# Technical Notice

IPX-9S-RS-R41

# iEi Products Technical Notice

**Model Name: IPX-9S-RS-R41**

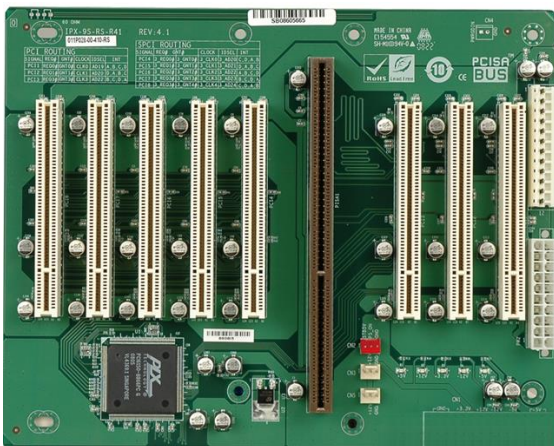
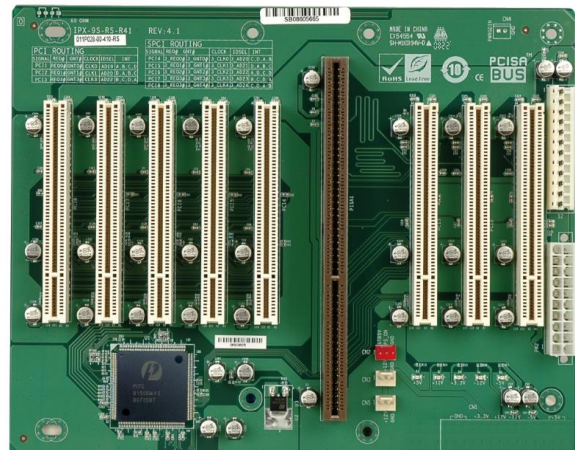
Due to the EOL of PLX PCI6150-BB66PC

Add Pericom PI7C8150BMAE as the substitute of PLX PCI6150-BB66PC.

**NOTE:** IC replacement is unlikely to cause any problem in normal use. However, if any technical issues occur, please contact sales representatives or FAE immediately.

**R.E.: Terminal block 1\*8 DIP;180°;P:6.35mm;BLACK EOL**

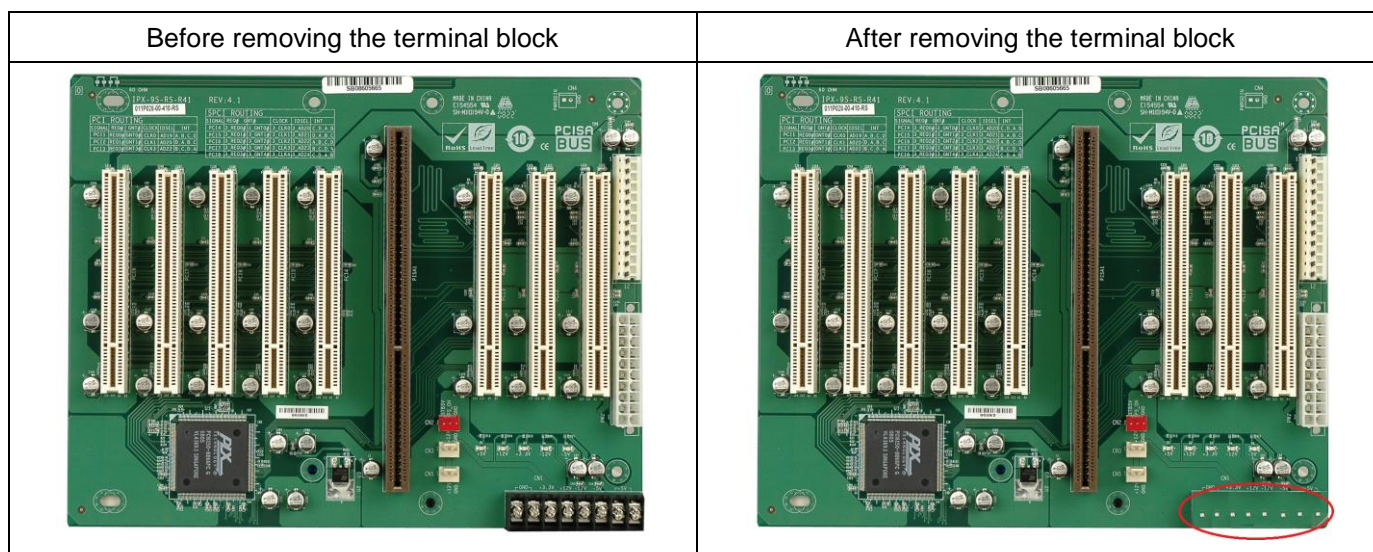
iEi appreciate your daily support on IPC business. Due to EOL of the terminal block 1\*8 DIP, iEi will remove the Terminal block 1\*8 DIP from IPX-9S-RS-R41.

You can refer to the figure1 for the difference between before and after removing the terminal block

**Solution: Remove the terminal block**
